Dear Editor,

## **Responses to the comments from Anonymous Reviewer #1**

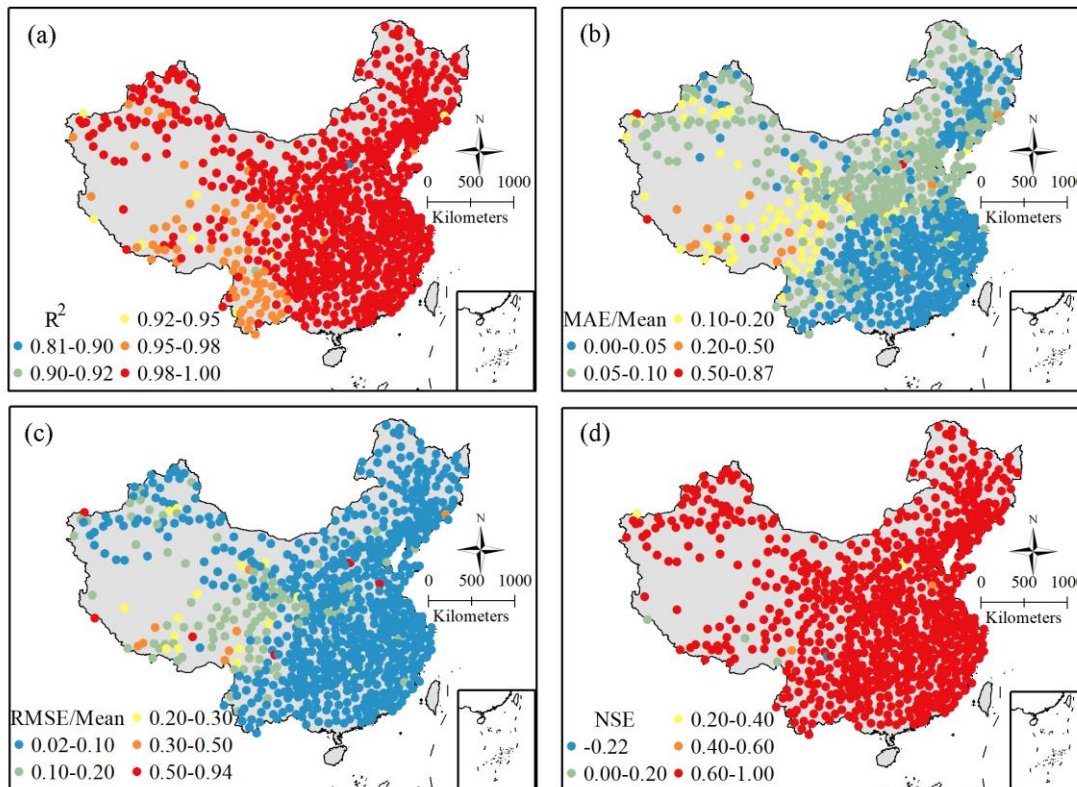
- Section 2.2.2 L108: Why did the authors use observational air temperature data from 824 stations, whereas they already mentioned before that they would like to use a high-resolution air temperature dataset to force the model. What is the added value of the observational air temperature data? What is the bias between the observational air temperature data and the high-resolution dataset of Peng et al., 2019 and to what is the difference between PDDs retrieved from the high-resolution dataset and PDDs retrieved from the observational data? Please elaborate on this.

We have presented the statistical analysis between PDDs retrieved from the high-resolution dataset and PDDs retrieved from the observational data in four different climatic zones of China, and the values of  $R^2$ ,  $MAE$ ,  $RMSE$  and  $NSE$  were shown in Table 1 in the original manuscript. To better illustrate the accuracy of calculated PDD, we added the statistical analysis at 824 meteorological stations. The added sentences are as follows:

Statistical analysis of the calculated monthly PDD against observed PDD at 824 meteorological stations shows the excellent performance at almost all of the stations (Fig. S5).

Figure S3. Projected future changes in precipitation in China and its three main stable snow cover regions. Historical: 1951-2017; RCP: representative concentration pathway.

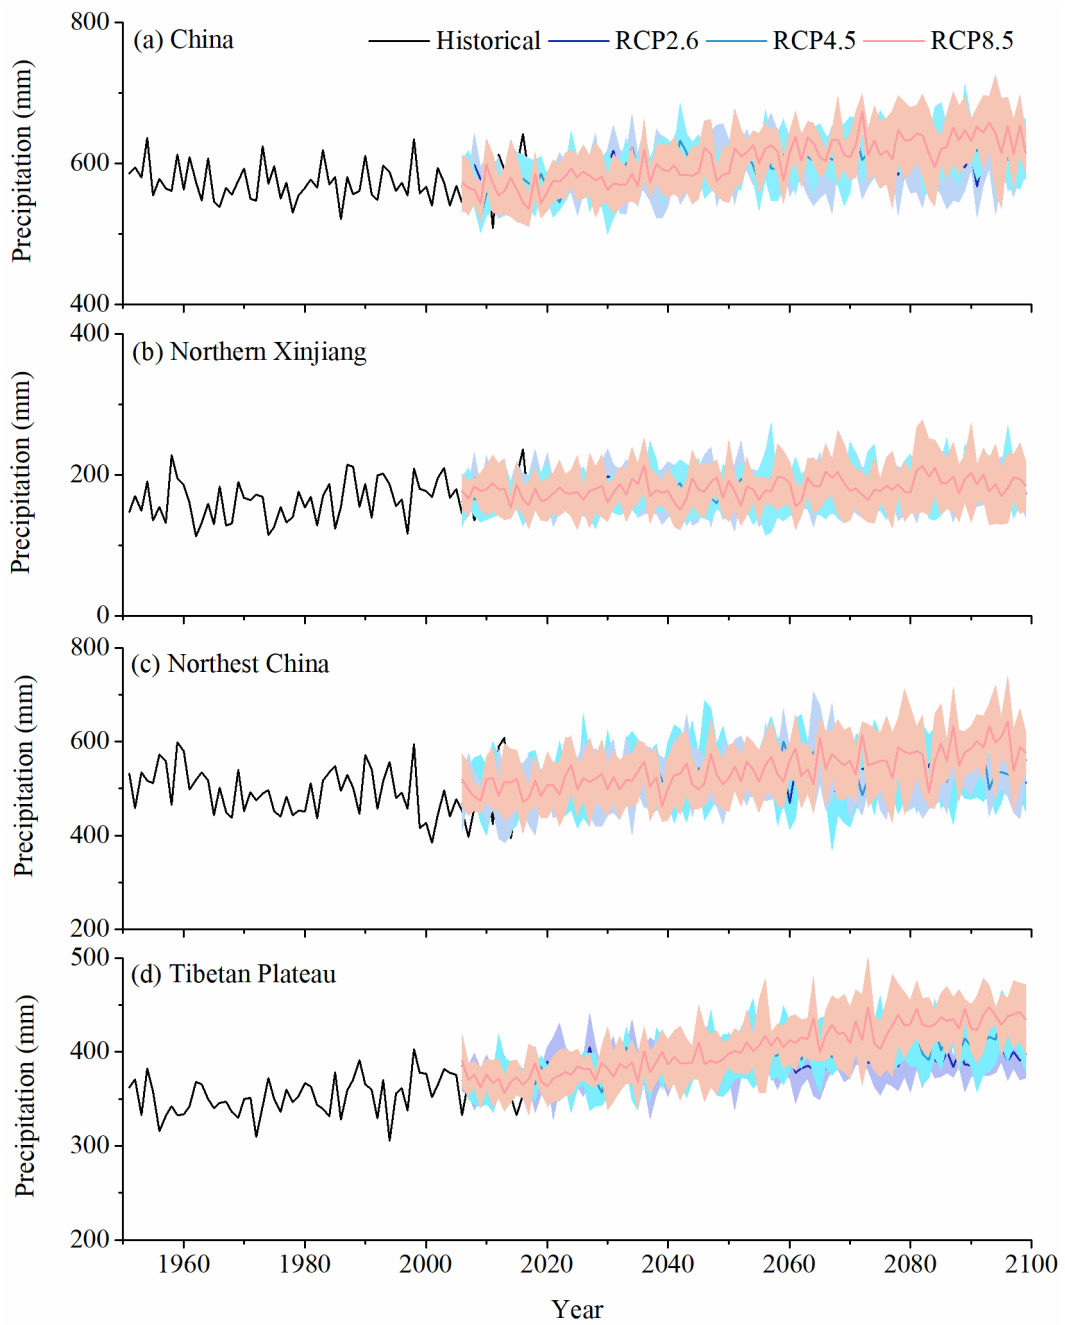
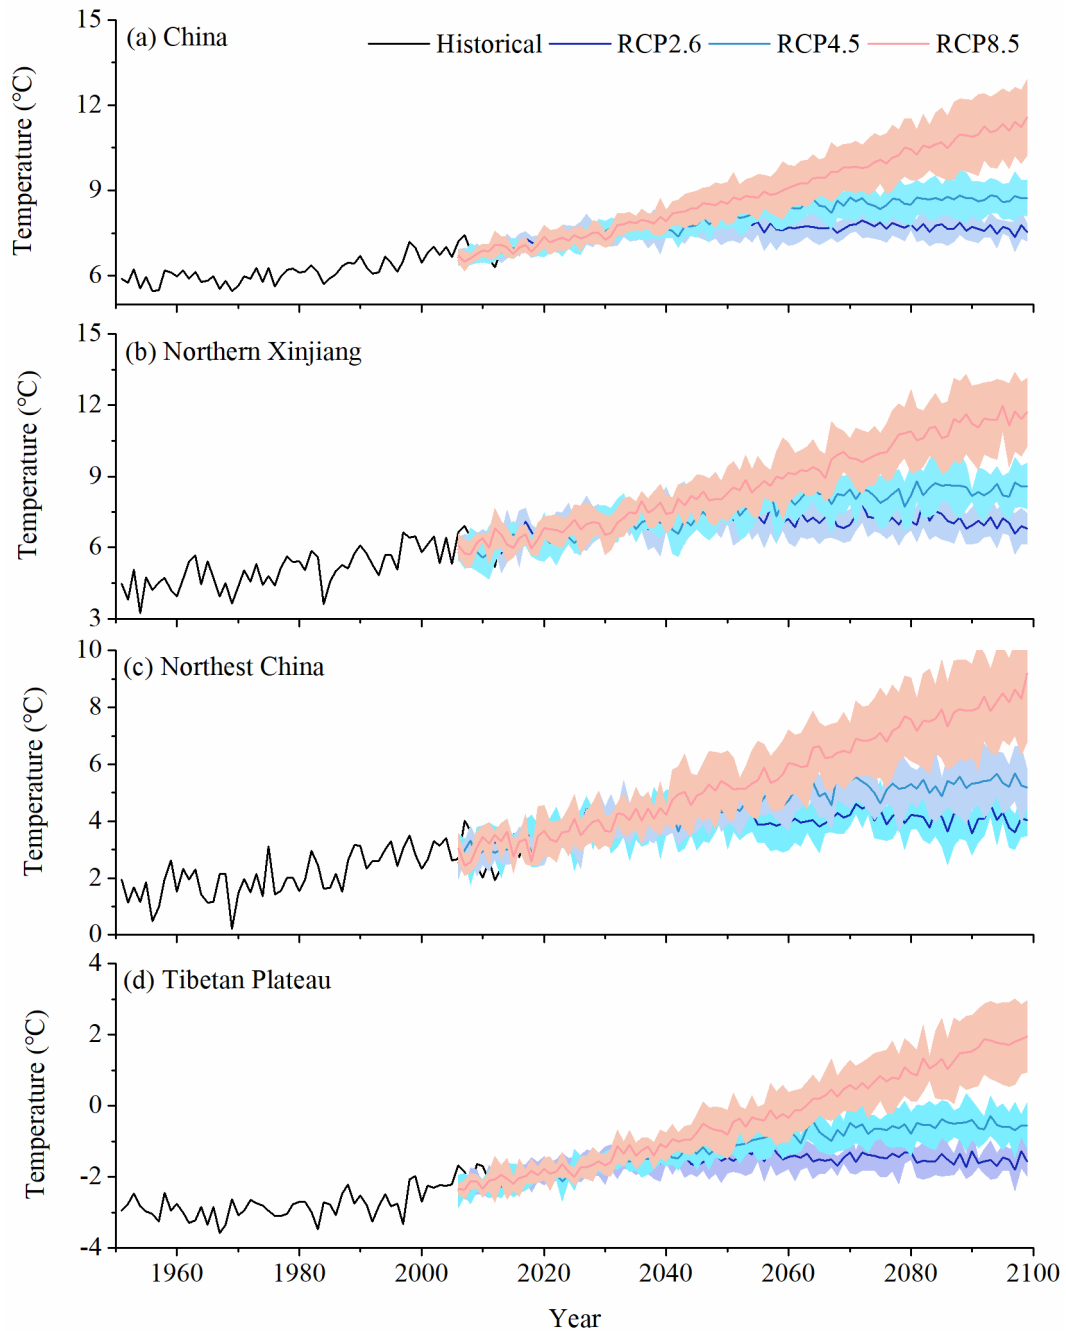
- Section 2.2.4; L135-136: Why did the authors only select these five CMIP5 models? Are the climate conditions in these models representative for the full range of possible conditions in terms of climate change (e.g. cold-dry, warm-wet)? What are the consequences for choosing these models for the outcomes of this study? And finally, it would be beneficial to show a few figures on the projected temperature and precipitation changes in China to put the projected changes of snowmelt in a better context.

We have added two figures on the projected precipitation (Fig. S3) and temperature (Fig. S4) changes in China and the added figures are as follows:

Figure S1. The first-level (a) and second-level (b) basins in China.

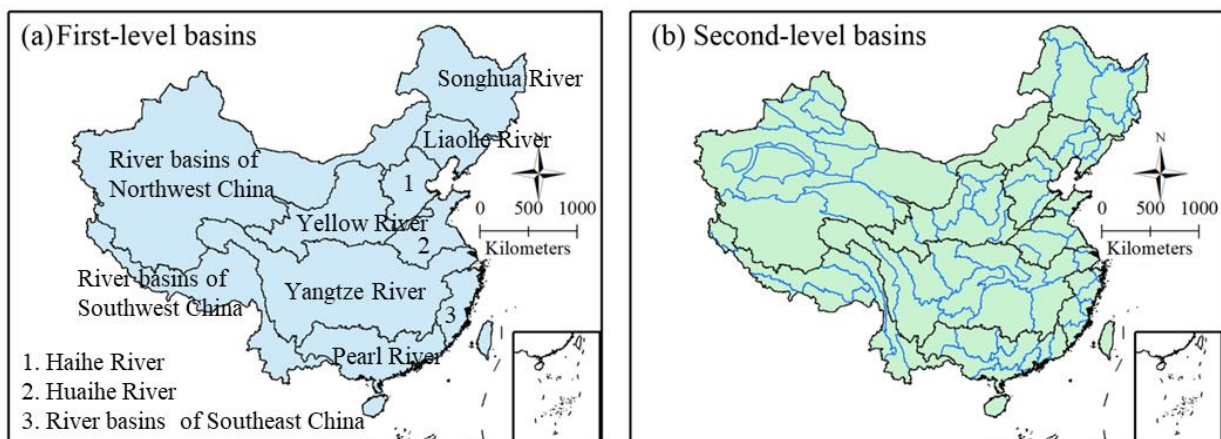
- Abstract; L20: From the abstract I cannot derive what “third level” stands for. Also, from the manuscript it is not clear what authors mean with “third level”. Therefore, I would like to suggest using “subbasin” instead of “third level”.

Response: Thank you for your suggestion. In our opinion, using “third-level basins” may be more appropriate than “subbasin” in this manuscript. The hydrologists in China have graded China's basins into first-level, second-level and third-level basins. We have added a figure to the Supplement, which we hope will help reviewer and readers understand the third-level basins in the manuscript. The added figure is as follows:

Figure S2. The threshold temperature ( $^{\circ}\text{C}$ ) for snowfall (a) and rainfall (b) at 485 meteorological stations in China.

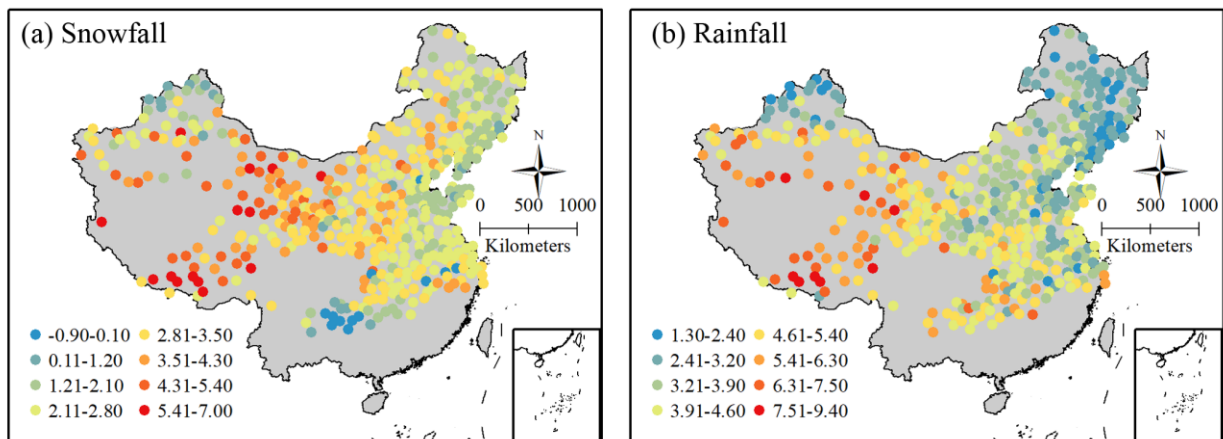
- Section 2.2.2; L114: Is this about the critical temperature defining whether precipitation falls as snow or rain? That there are different threshold makes sense, but it would be good to map this as well for the readers convenience.

- Section 3.1.1; L159: The threshold temperatures are described, but not presented as a main result, which makes it difficult to imagine what the numbers are. Is it possible for the authors to present those numbers by means of a table or figure, either in the manuscript or the supplementary information?

Response: Yes, this is about the critical temperature. We have added a figure to the Supplement, and the added figure is as follows:

Response: We have added a figure to the Supplement, which can be found in the previous response (Figure S2).

Figure R1. Spatial distribution of the mean snow water equivalent (SWE) in August 2017 in China (a) and spatial distribution of glaciers in China (b).

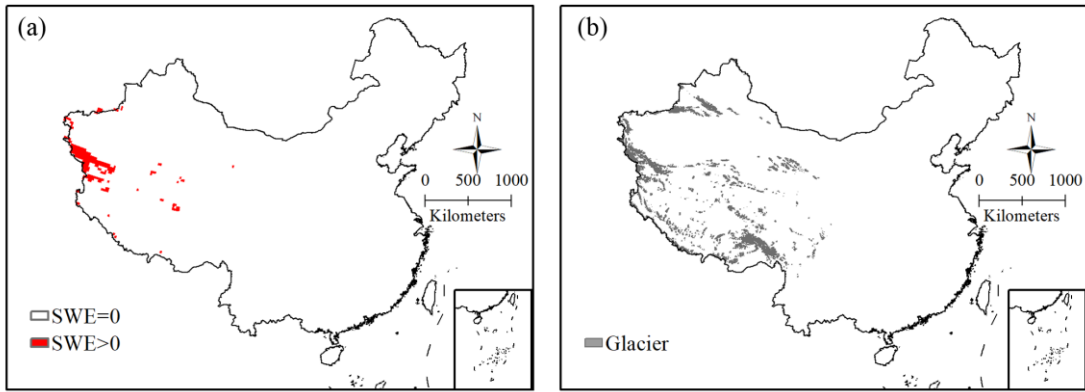
- Section 4.1.4; 299-306: I consider this argumentation as insufficient. Firstly, that the microwave remote sensing data have a spatial resolution of 25 km does not mean that relatively small glaciers are not recorded. At least, I think the authors should be able to substantiate why this is the case (e.g. by means of scientific literature) and whether it is a common problem for microwave remote sensing data. Secondly, since the authors decided to use the last day as a monthly observational representative the chance is very likely that the snow water equivalent on that particular day is 0, whereas the mean monthly snow water equivalent would have been different. This might explain as well why there is a discrepancy between the observed data and the simulated data. To my opinion, the authors need to elaborate more on this point.

Response: We believe that the resolution of microwave remote sensing is the main reason why relatively small glaciers have not been recorded. Fig. R1a shows the spatial distribution of the mean snow water equivalent in August 2017 in China, and Fig. R1b shows the spatial distribution of glaciers in China. The mean snow water equivalent of 0 in August means that the snow water equivalent of every day in August is 0. As can be clearly seen in the figure, most of the glacial regions in the Tibetan Plateau have a mean snow water equivalent of 0 in August, indicating that the data retrieved by the microwave remote sensing has not recorded the snow water equivalent of those glaciers. We have consulted Lingmei Jiang, the producer of snow water equivalent data, and Tao Che, the producer of snow depth data, both of whom are experts in microwave remote sensing, and they both agree with us. Regarding the second point of this comment, since the model determines the monthly snow accumulation based on the amount of snow remaining after melting, we prefer to use the snow water equivalent on the last day of the month to validate the snow accumulation.

Figure S8. The location of the Qaidam Basin, Qiangtang Plateau and Mountains on the Tibetan Plateau.

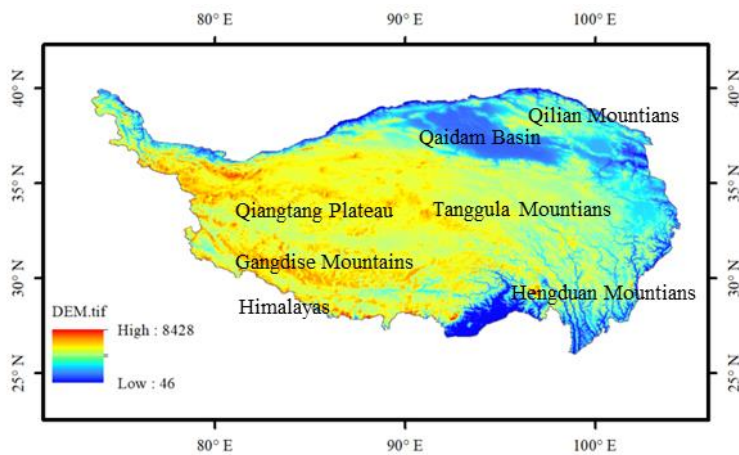
- Section 4.2.1; L333: Here and throughout the manuscript, many readers have most likely no idea where most of the geographical areas are located. Therefore, I would like to recommend adding those locations to a map or to give an indication where these areas are located, such as West China or via some lat-lon coordinate.

Response: Thank you for your comment. In the Supplement, we have added a figure about the geographical distribution in the Tibetan Plateau (Fig. S8 in the revised manuscript), and we hope this figure is helpful to readers. The added figure is as follows:

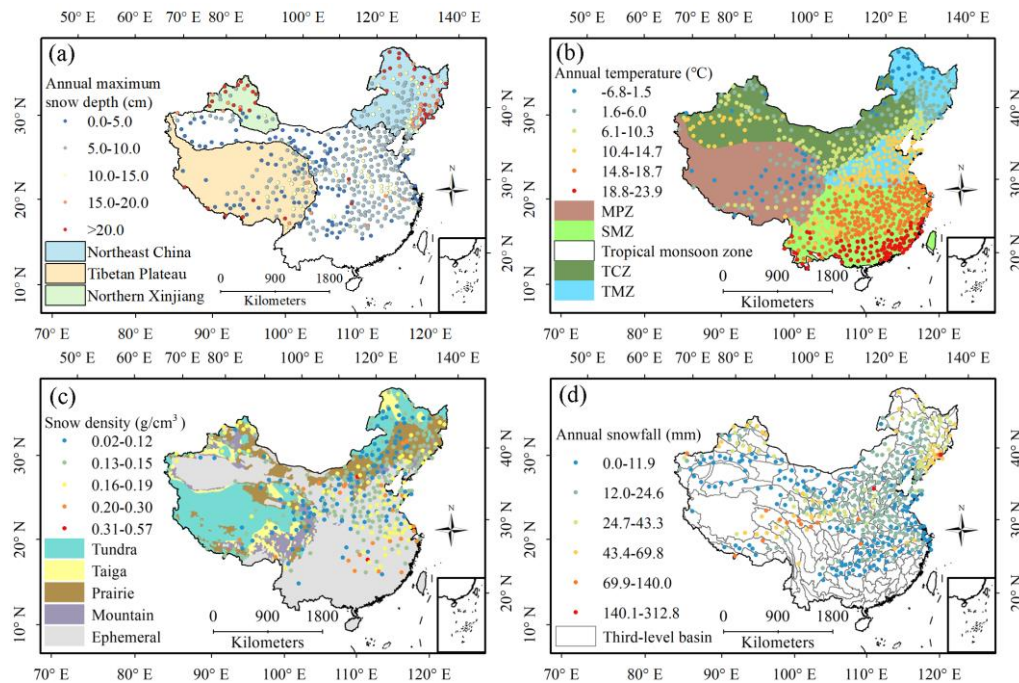
7. Line 93: Figure 1a showed the mean snow depth from 557 meteorological stations in China. The mean snow depth is little significant, and it is better expressed by accumulated snow depth or the maximum snow depth. Figure 1c. Please use 3 as superscript in  $\text{cm}^3$ .

Response: Thank you for this comment. We have revised the the mean snow depth to the maximum snow depth in Figure 1a, and we have revised the unit in the Figure 1c. The revised figure is as follows:

Figure S2. The threshold temperature ( $^{\circ}\text{C}$ ) for snowfall (a) and rainfall (b) at 485 meteorological stations in China.

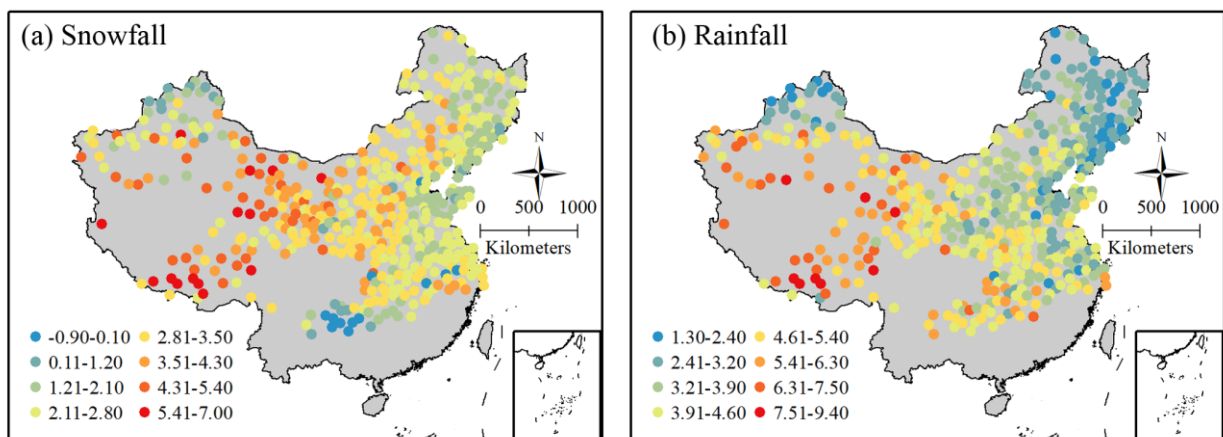
10. Line 115: The threshold temperature in China in this study should be shown in this manuscript by figure or table, or partly shown, I suggest.

Response: Thank you for your suggestion. We have added a figure to the Supplement, and the added figure is as follows:
